SUBJECT: Forwards addl info in response to NRC 940224 ltr on GL 87-02
 re resolution of USI A-46.

Subject: St. Lucie Unit 1
Docket No. 50-335
Turkey Point Units 3 and 4
Docket Nos. 50-250 and 50-251
Verification of Seismic Adequacy of Mechanical
and Electrical Equipment in Operating Reactors
Unresolved Safety Issue (USI) A-46
Generic Letter (GL) 87-02

ATTACHMENT B
ADDITIONAL DESCRIPTION OF FPL RELAY EVALUATION PROCESS
IN RESPONSE TO NRC LETTER DATED FEBRUARY 24, 1994

RESPONSE TO THE NRC REQUEST FOR
ADDITIONAL INFORMATION (RAI) DATED JUNE 23, 1993

FPL A-46 RELAY EVALUATION PROGRAM

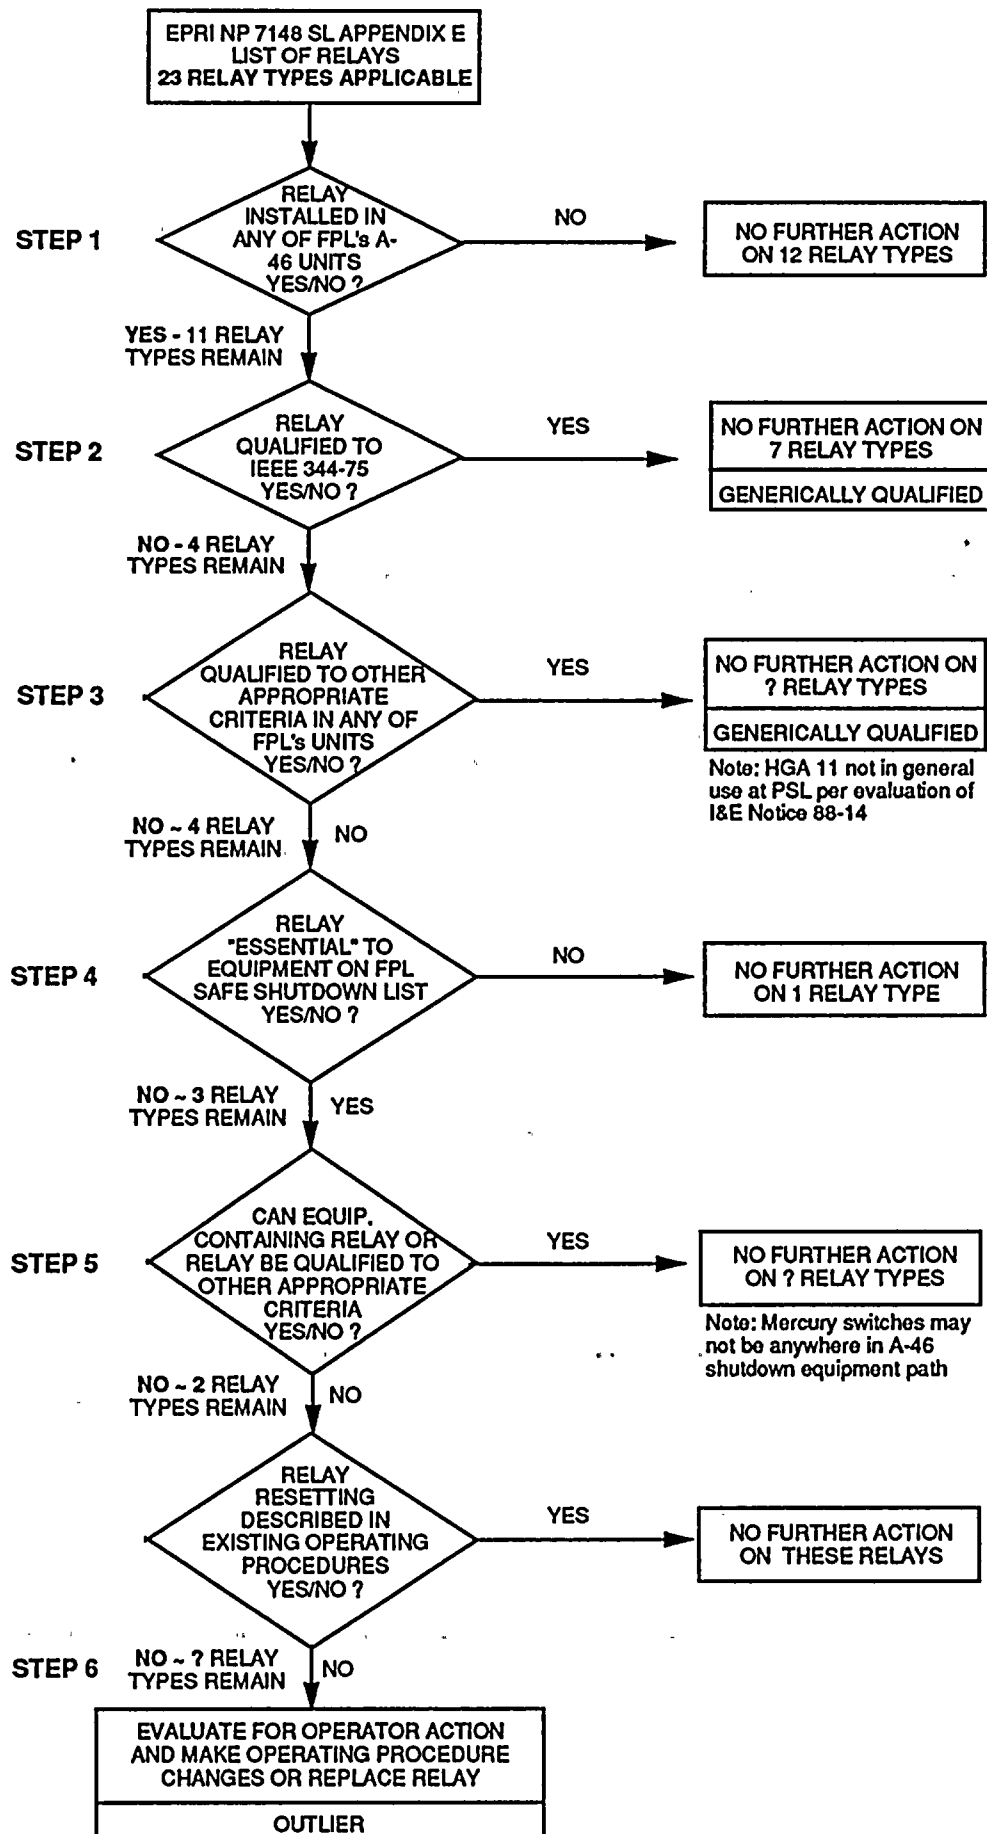
Please note that this description is provided for better understanding of the process. All data at this point are preliminary. Note that the Step numbers correspond to the flow chart attached to this description.

Step 1. Begin with EPRI NP 7148SL Appendix E list of relays (EPRI list).

Step 2. The next step is to determine if any of these remaining relay types has been qualified to IEEE 344-1975 criteria for our site specific demand. If so, they are sufficiently rugged for our low seismic zone.

Thus 7 relay types are qualified for FPL's low seismic demand. This leaves 4 relay types to evaluate after Step 2 is completed.

- Step 6. Any relays not qualified in the previous steps are considered to be "outliers" and appropriate procedural action would be taken or the relays would be replaced. If existing operating procedures or procedure changes can safely address potential chattering of "outlier" relays, they will not need to be replaced. However, if a major engineering design change to the equipment is made in the future, IEEE 344 qualified relays would be used as replacements.
